Reference: 2083 Bustard Road – Sewage Facilities Planning Module

Reference: Huganir Property Subdivision – Mikelen, LLC
Preliminary Plan Review

RE: **Traffic Review #3 – Preliminary Subdivision and Land Development Plans**
Huganir Property – Proposed Residential 8-Lot Subdivision
Worcester Township, Montgomery County, PA
McMahon Project No. 821068.11

Re: MCPC #21-0025-002
Plan Name: Huganir Property
(1 lot comprising approx. 17.4 acres)
Situates: Artmar Road and Nicole Drive
Worcester Township

OVERALL SUBDIVISION PLAN
RECORD PLAN 2 OF 5

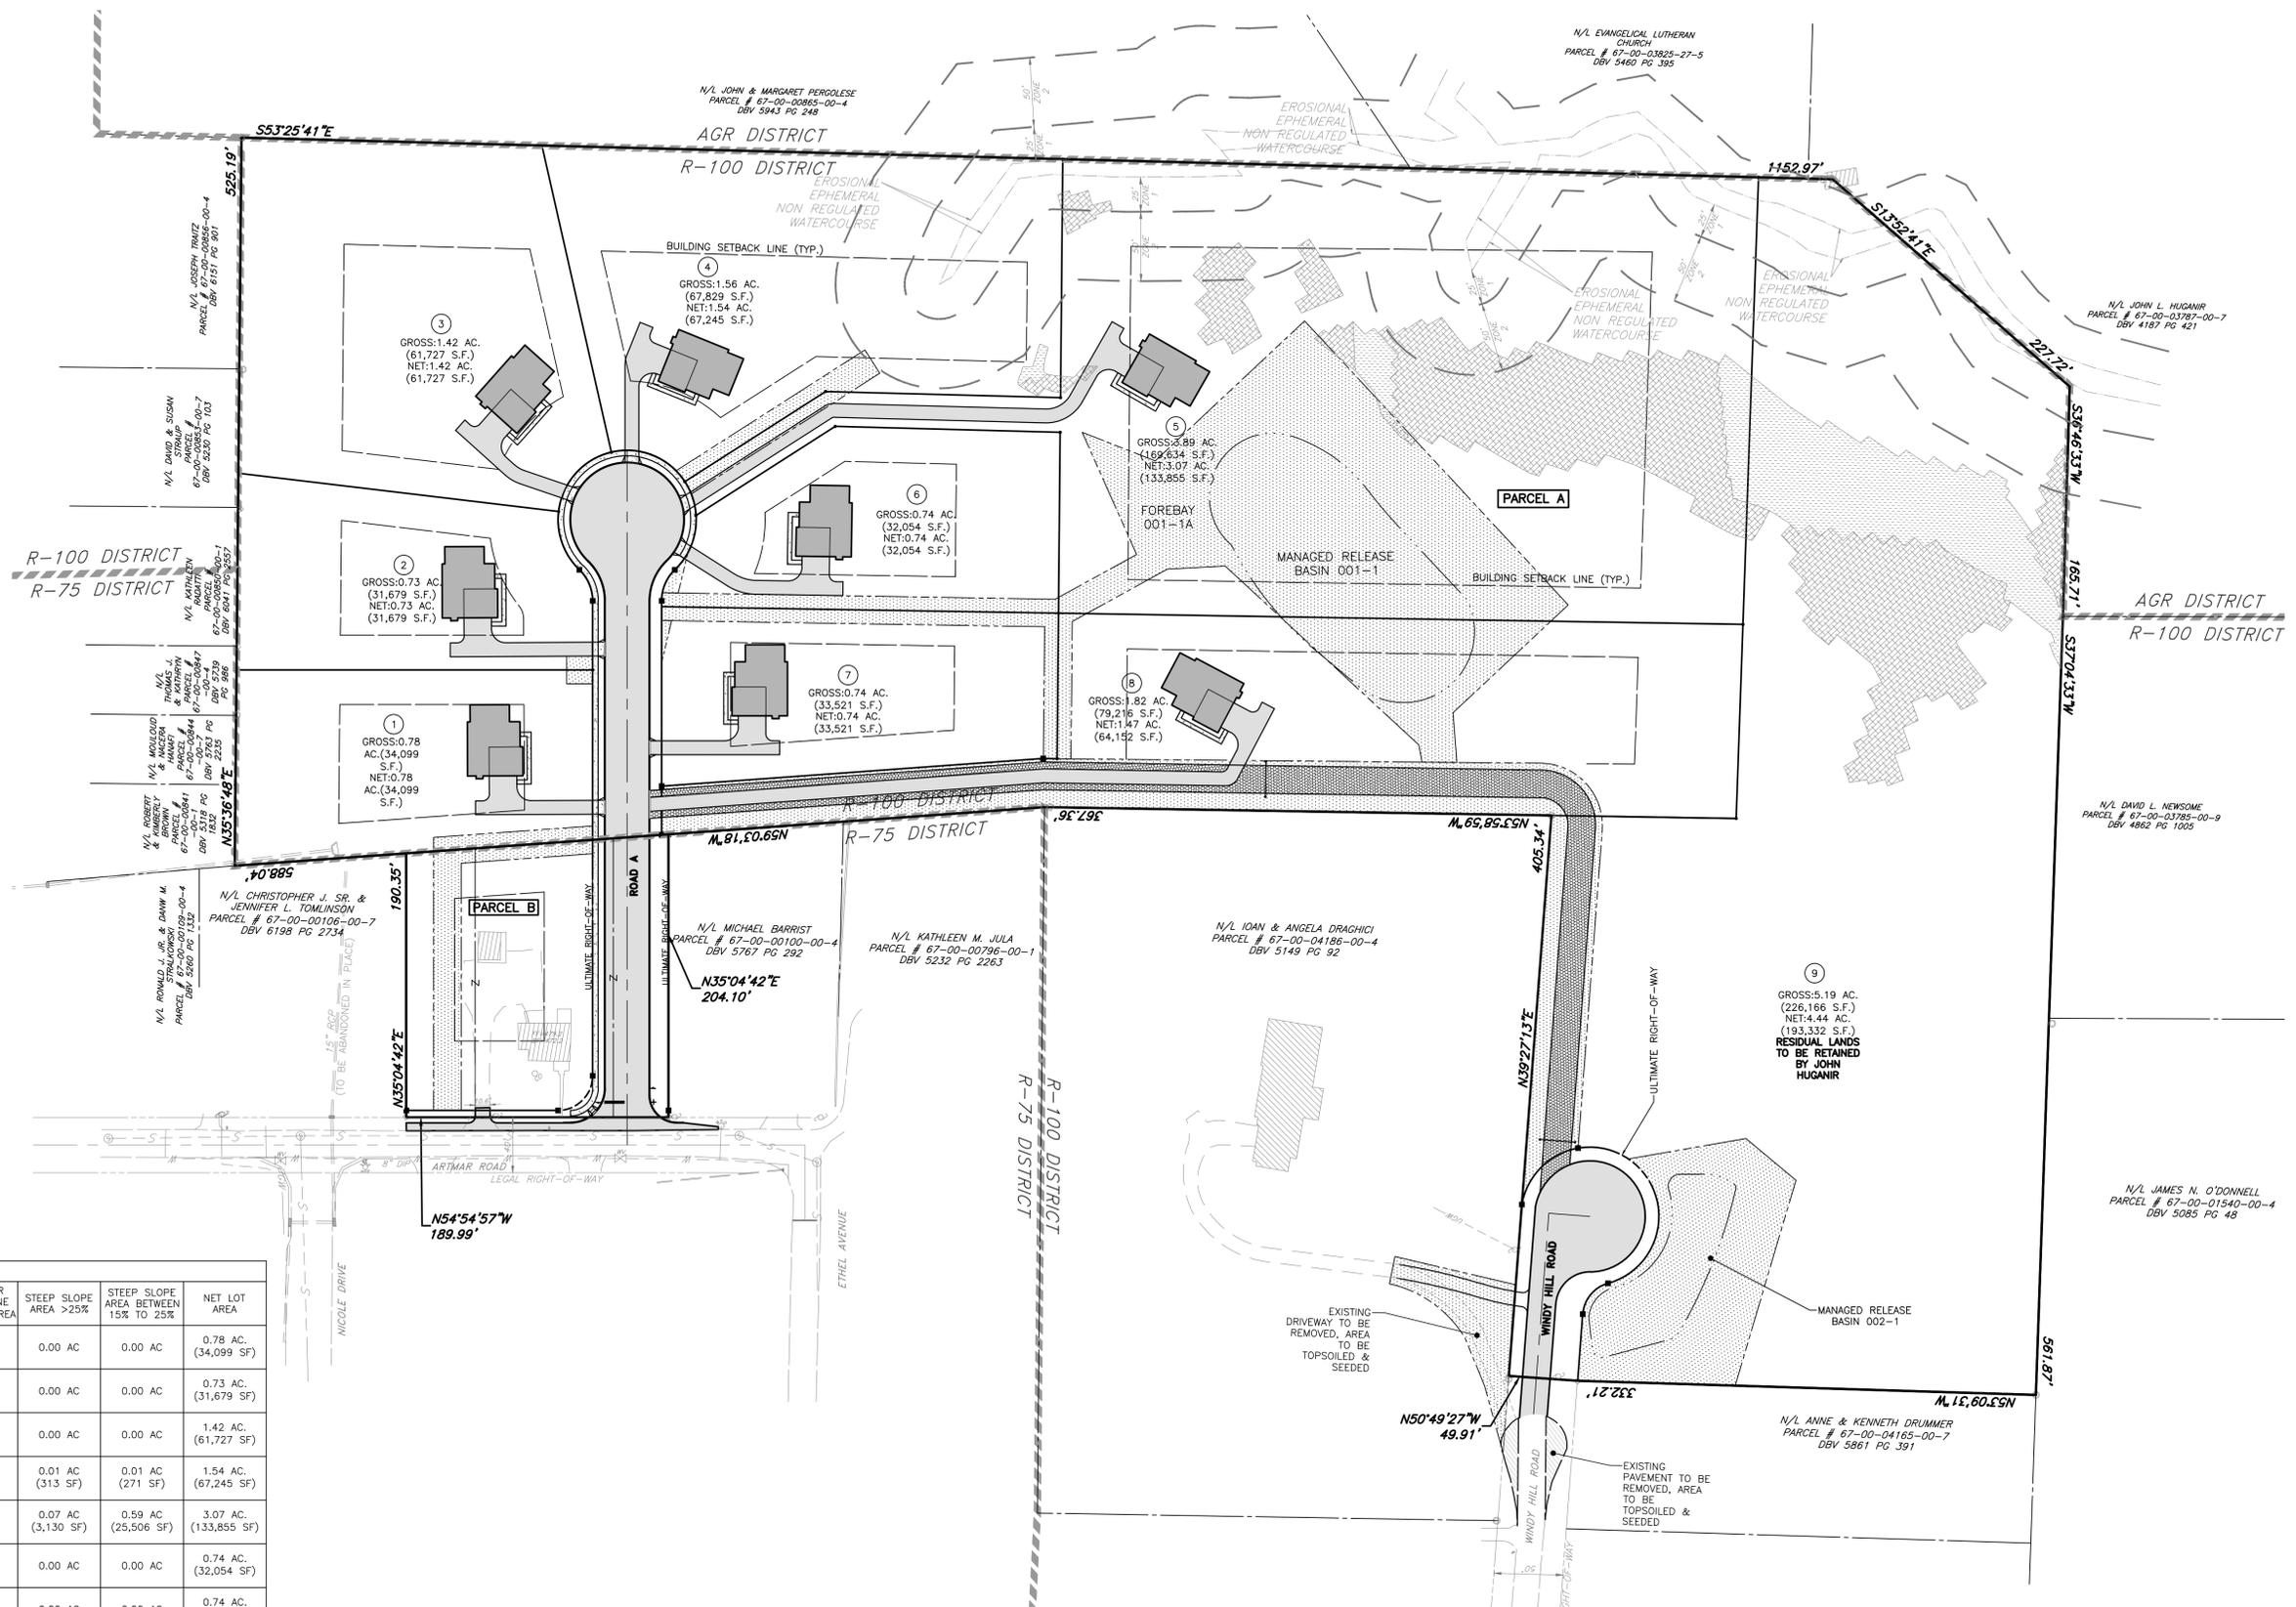
3. On Sheet 6, Note 14 sets for the maintenance responsibility for the stormwater basins on Lots 5 and 8. The applicant should prepare the required easements and the maintenance agreement that will need to be executed between the lot owners. These documents should be reviewed and approved by the Township Solicitor and recorded along with the lots.

13. As previously requested, an impervious coverage table has been added to the Post Construction Stormwater Plan. This table and the accompanying Note No. 5 must be added to the overall Record Plan.

14. The 100-year WSEL for both MRC basins must be shown the record plan.
15. The new pipe between inlets E6 and E.2 must be shown as proposed in plan view.

SUBJECT
 OVERALL SUBDIVISION PLAN
 RECORD PLAN 2 OF 5
HUGANIR PROPERTY
 WORCESTER TOWNSHIP, MONTGOMERY COUNTY, PENNSYLVANIA

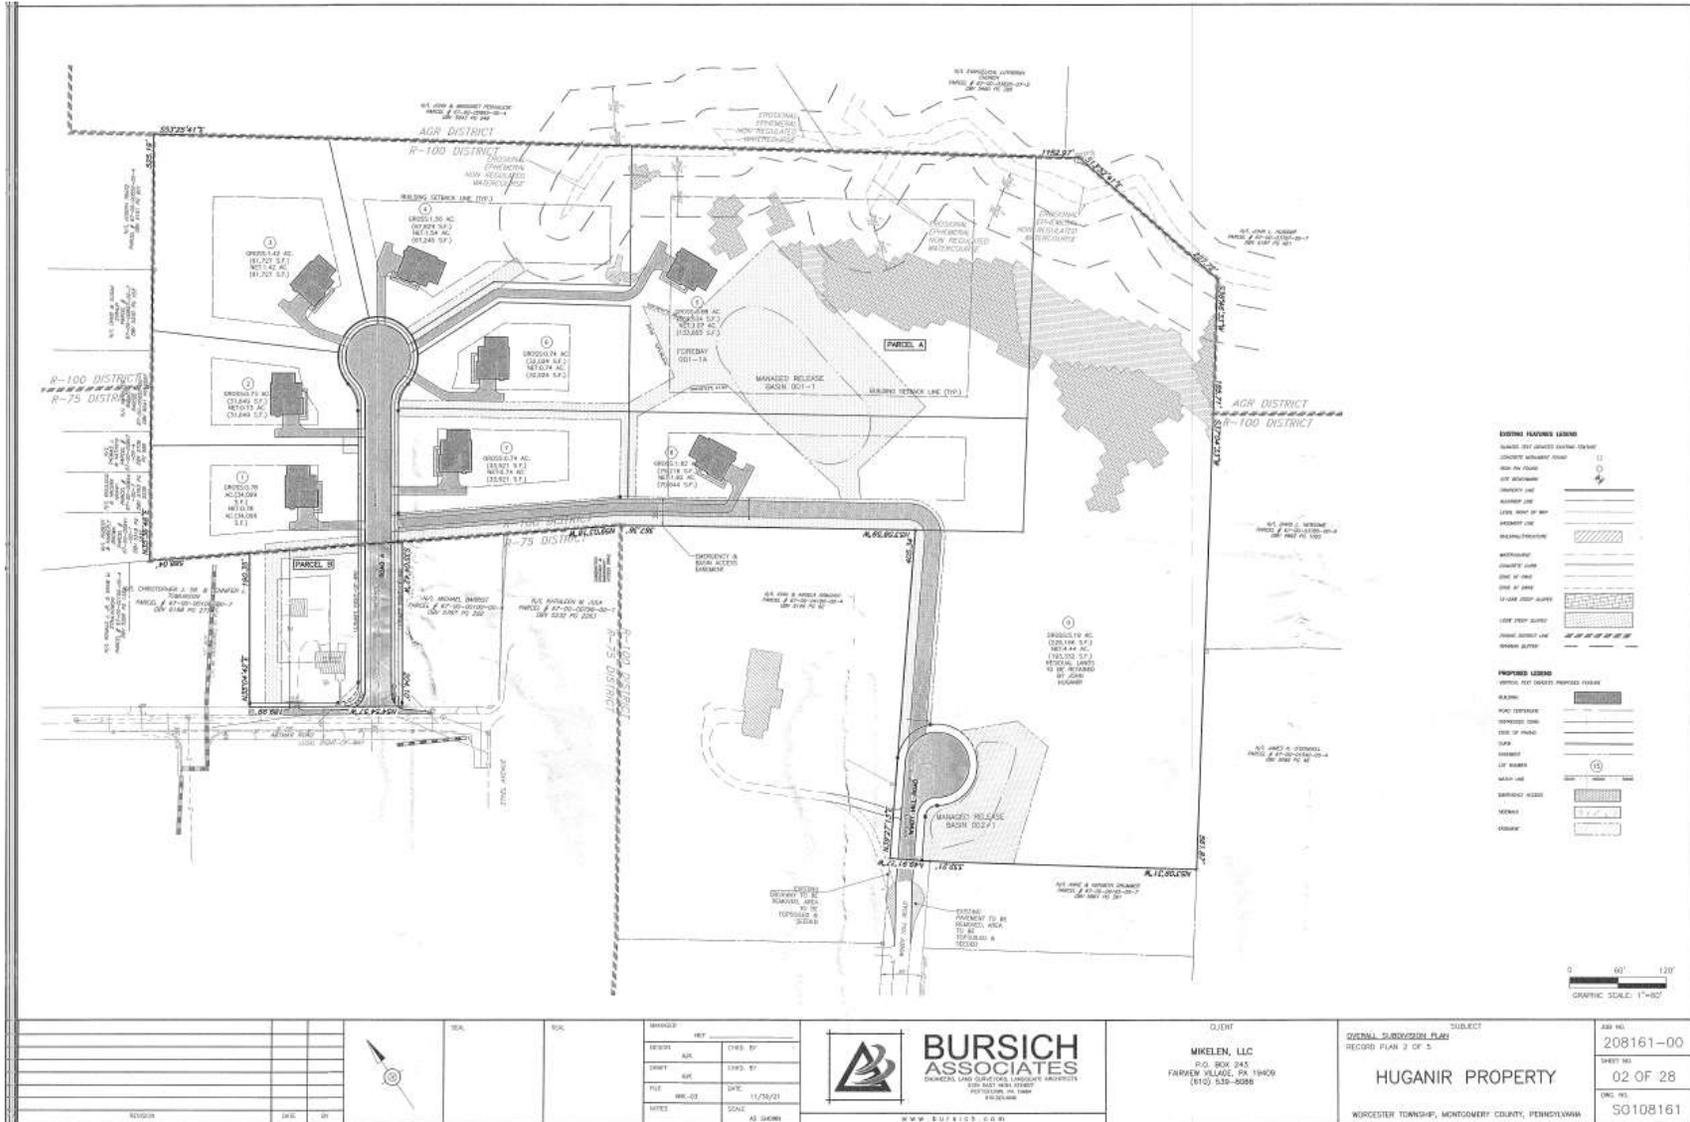
1. Road Access. *Comment A.1 of our previous letter still applies to this submission, which we reiterate, in part, here:* As stated above, the Applicant proposes an access road to the Property, which currently does not have road frontage, through an existing house lot. However, there are several issues with the placement of the road. The proposed access road's proximity to the right-angle turn south in Artmar Road is not ideal, and may induce sight-distance issues. Moving the access road to the other side of the existing house may improve this. Additionally, adding more housing units onto Artmar Road will ultimately add more units to a neighborhood with only a single means of egress, which could be problematic—having a second means of egress, or different means of access entirely, may be preferable.

In this revised submission, the Applicant is improving Windy Hill Road by adding a slight extension and an improved cul de sac, from which an emergency access route is planned through the site to the new 'Road A.' While it does provide needed circulation and a potential second entrance into the neighborhood for emergency vehicles, this still does not solve the everyday circulation issues described above. We recommend that the Applicant reconsider this approach.

3. Stormwater Management. The Plan indicates a stormwater basin that will lie across two different lots (Lots 5 and 8): we would not recommend that such a basin be split between two different owners. Especially for Lot 5, the usage of much of the back yard would be limited due to the restrictions inherent in managing the basin's integrity: the Applicant should rethink this design. Furthermore, it is not clear what the Applicant envisions for the management of the two basins (e.g. if there will be an HOA that maintains the basins), since they both are located on private property and not a common area.

4. Landscaping. One of the waivers proposed by the Applicant is for **Section 130-28.F.7** for the replacement of trees over 6" in DBH. In considering whether to grant this waiver, the Township may wish to consider alternative means of compliance, such as the planting of some of the required trees elsewhere, or a potential fee in lieu of planting all of the required trees.
